Project 23029 – The Landing 3.0  
New Construction – 555 S. Harrison St. Fort Wayne IN, 46802

## **ADDENDUM No.2**

October 4, 2024

**Addendum #2**

Item 1: C-401 Site Utility Plan

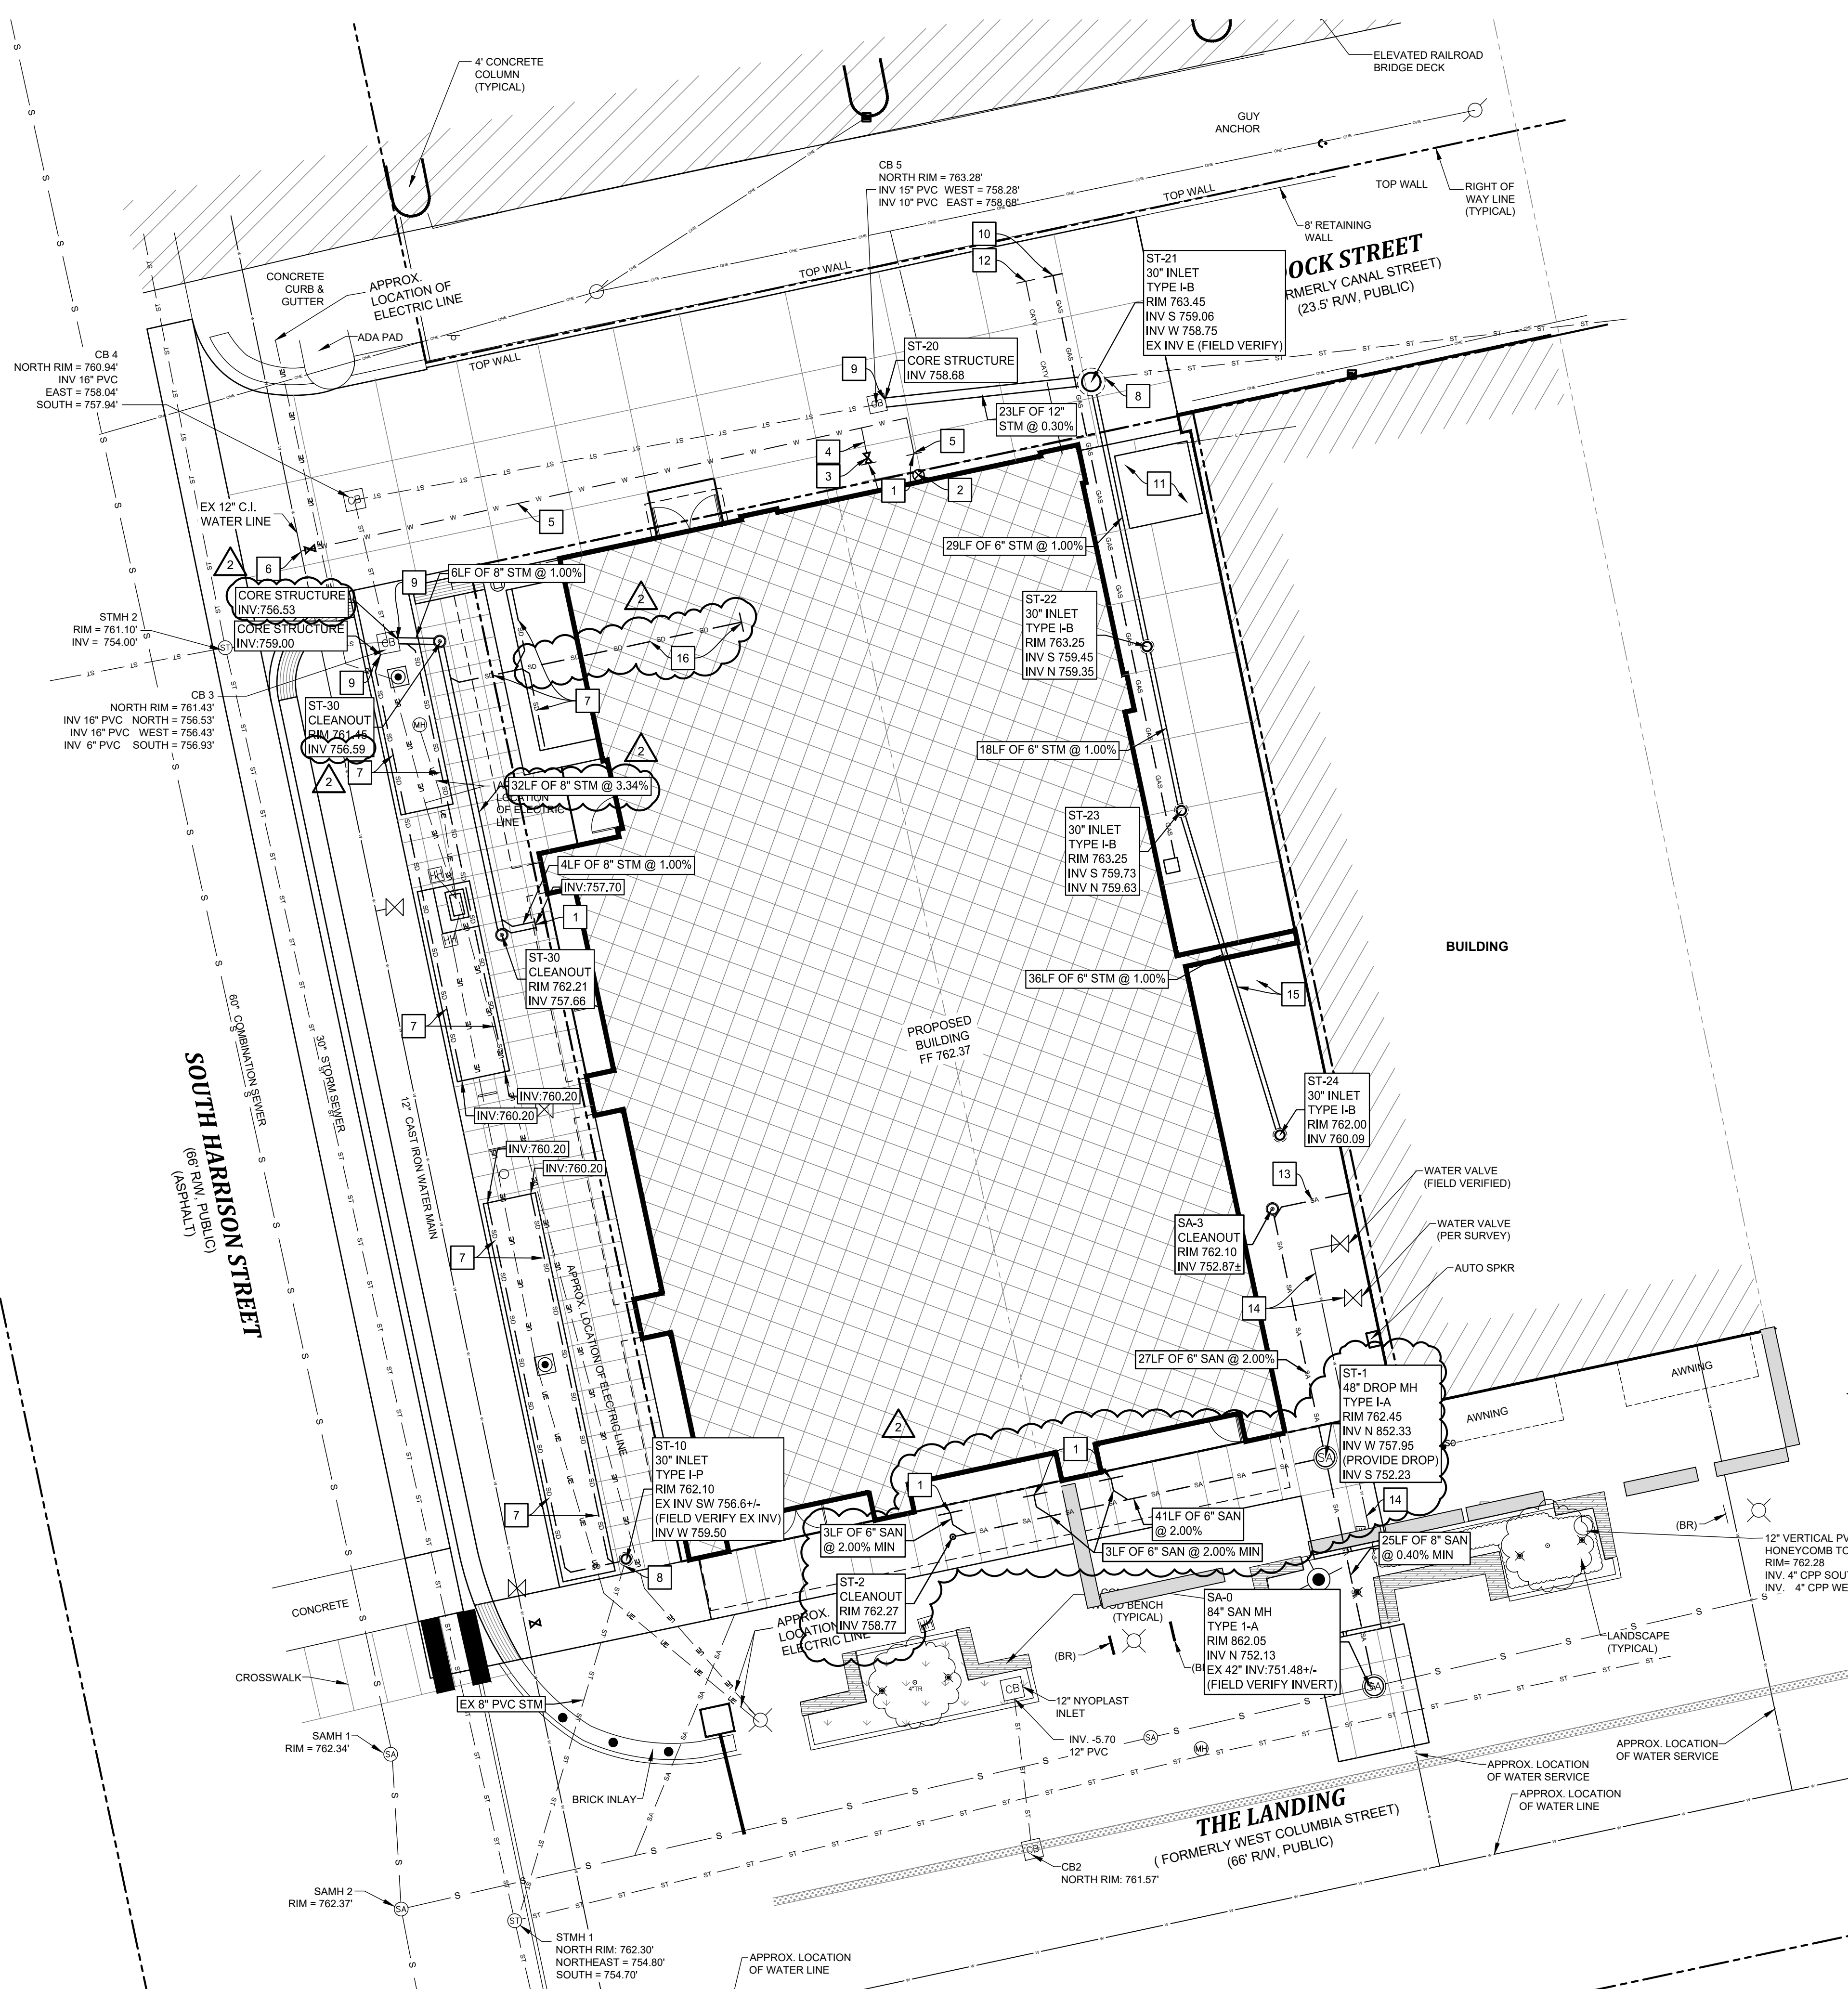
Description: Revise / Add

- A. Revise sanitary sewer building connections to match plumbing sheets.
- B. Add subdrain to extend to elevator pit and adjust downstream storm sewer to accommodate elevations.

- EXTEND 4" PERFORATED SUBDRAIN TO ELEVATOR PIT AND CONNECT TO ELEVATOR PIT PERIMETER DRAIN PER ARCHITECTURAL DRAWINGS. SLOPE TO DRAIN.

DRAWING CONTENTS:  
 INTERIOR WALL TYPE LEGENDS

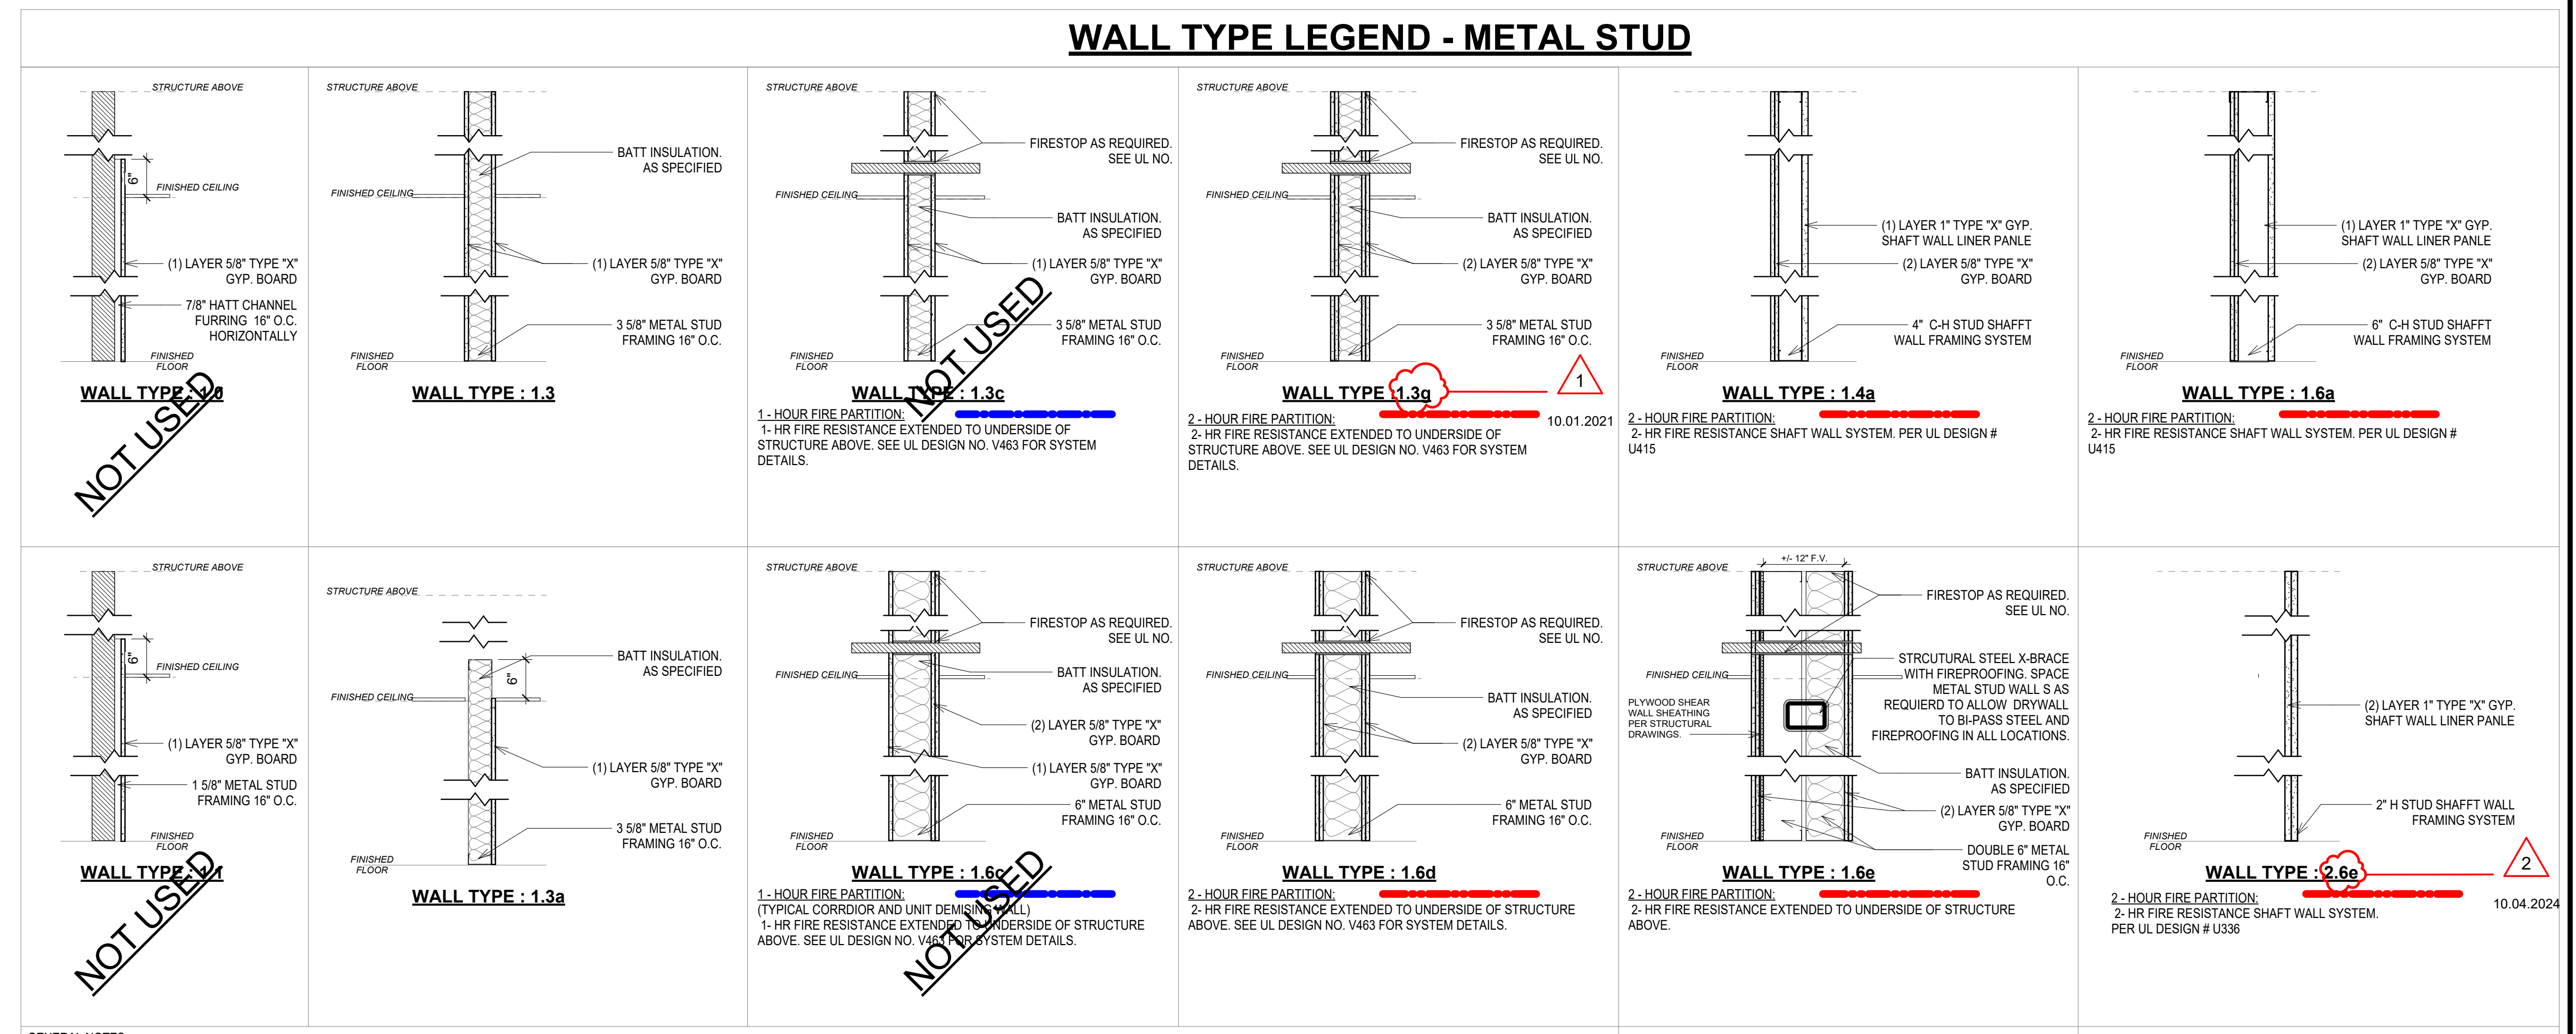
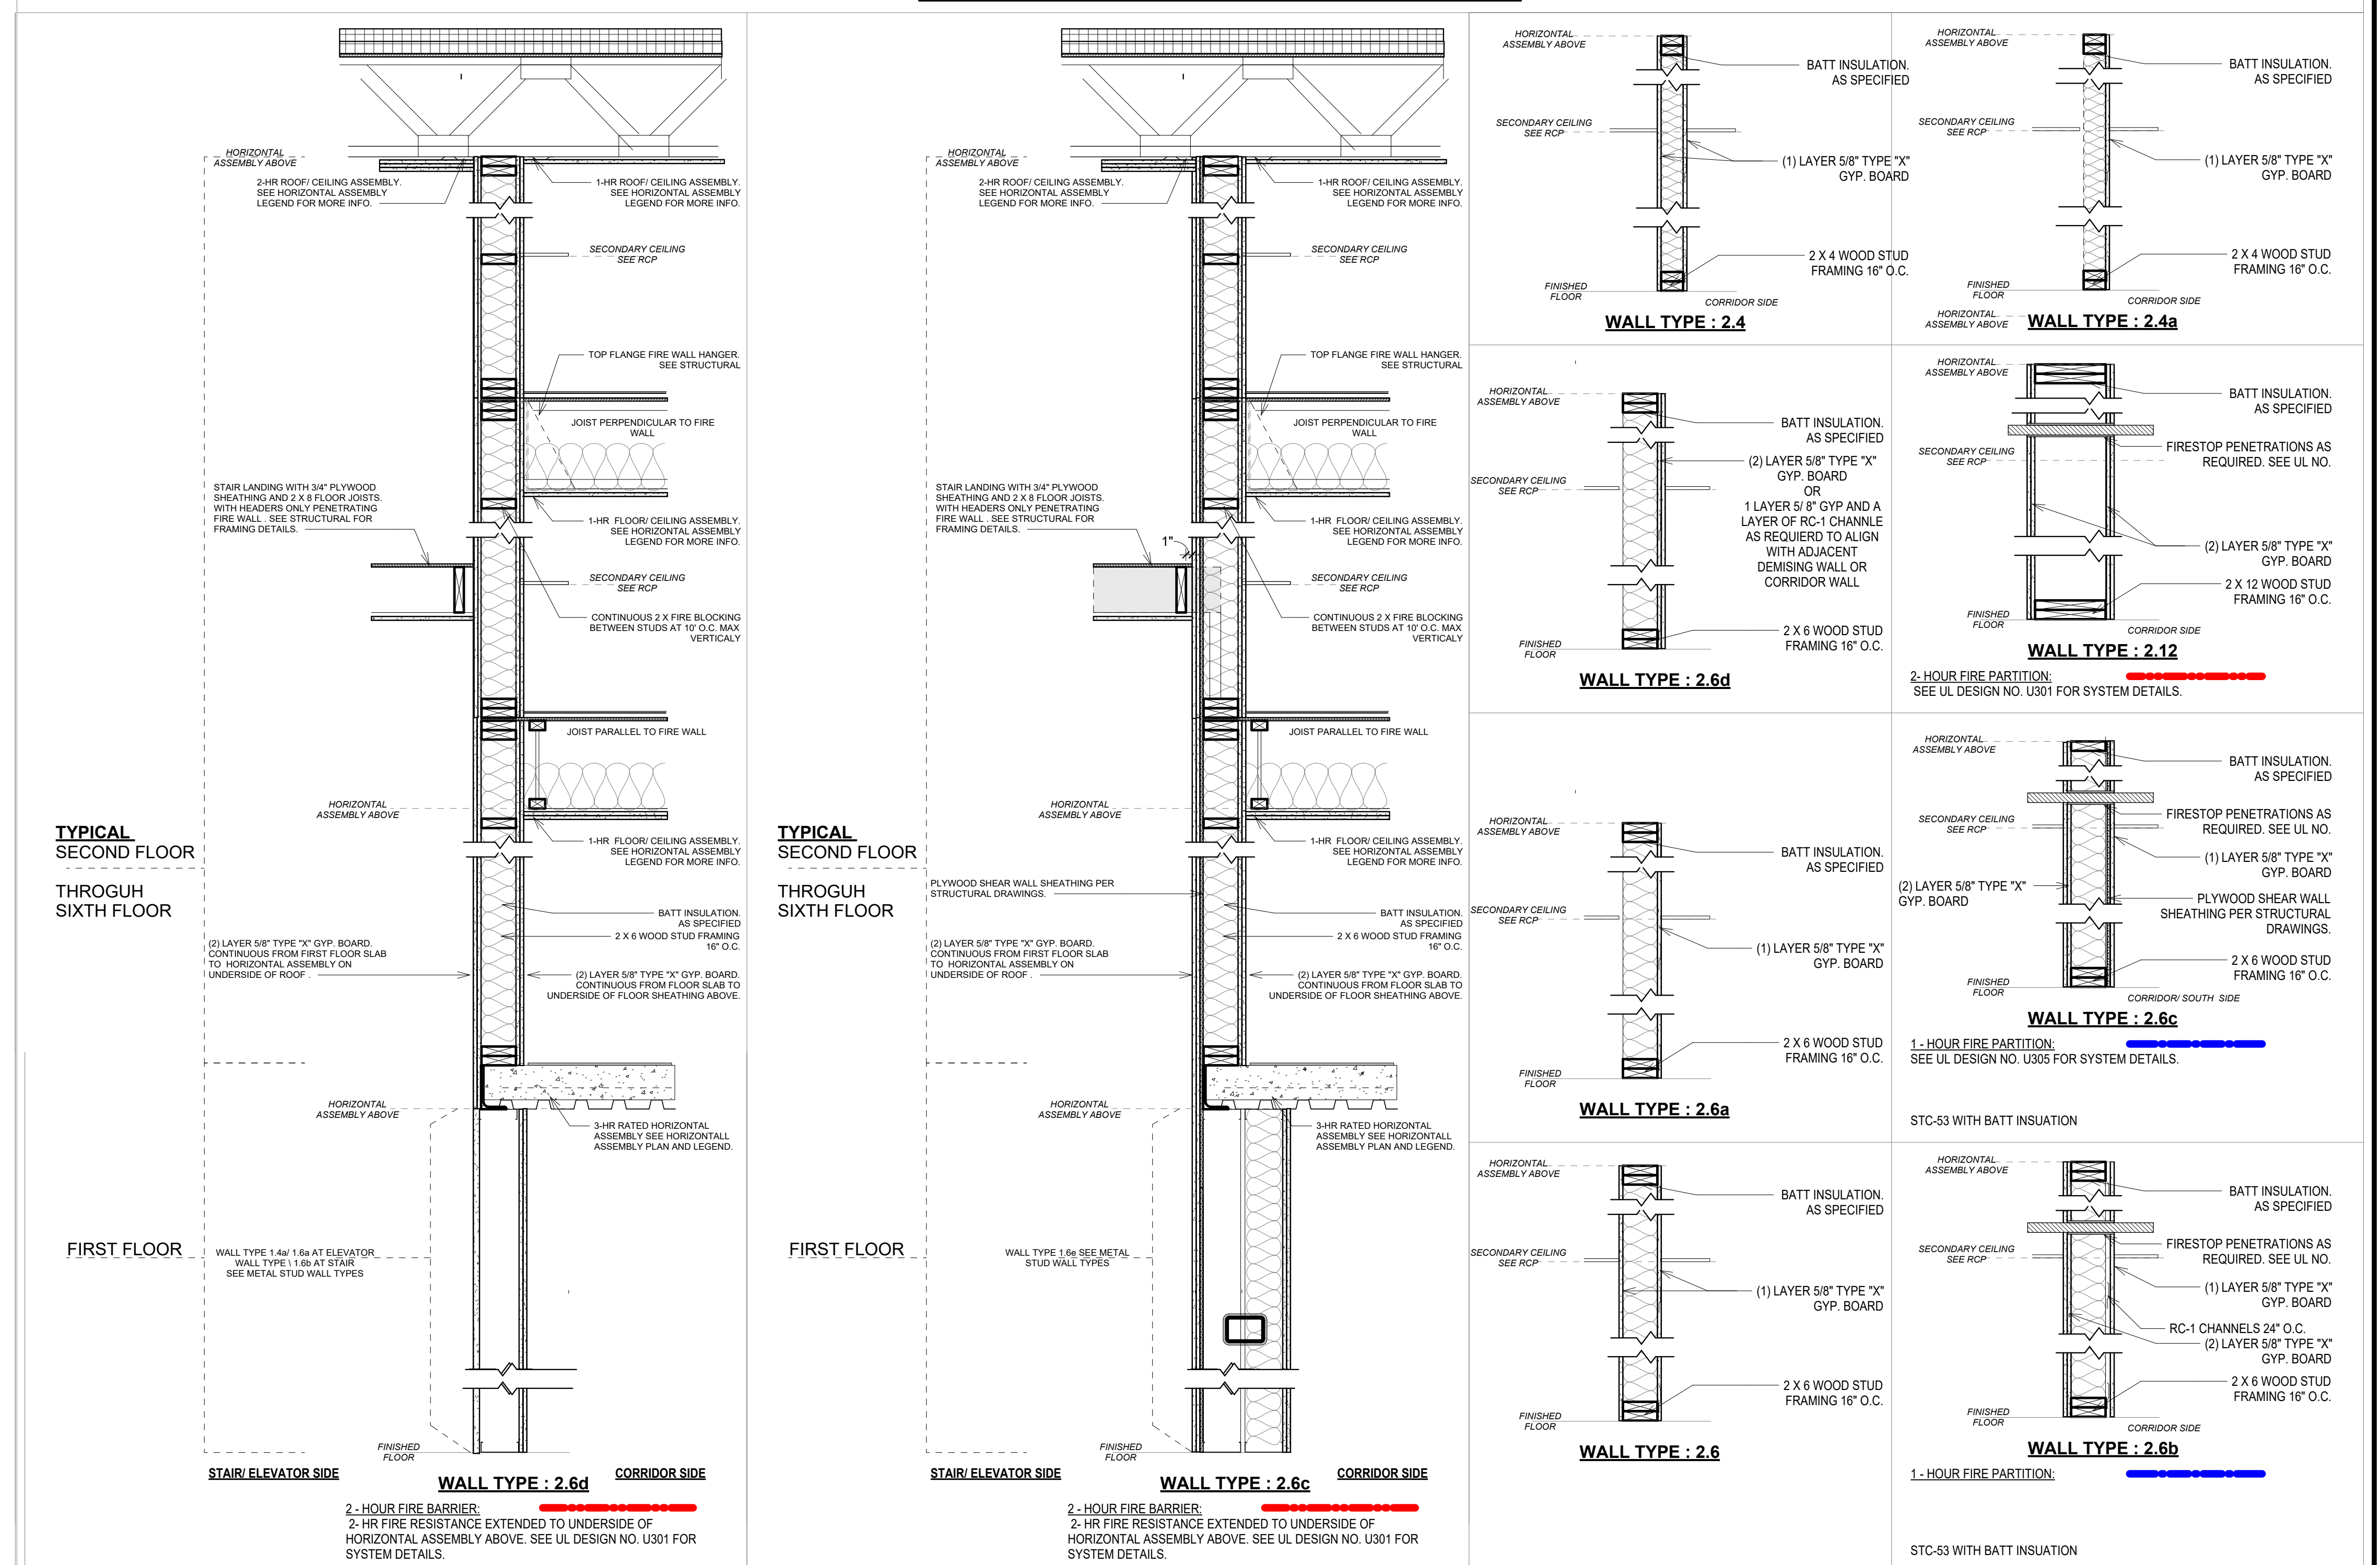
1. Sheet A-010 – Interior Wall Type Legend
  - a. Clarification: See attached revised sheet with the revisions to wall type 1.4a & 1.6a wall type.
2. Sheet A-322 – STAIR SECTIONS
  - a. Clarification: See attached revised sheet with the revisions to detail #12 showing stair handrails as field painted steel pipe handrails in lieu of stained wood handrails.
3. See attached Civil Addendum #2.
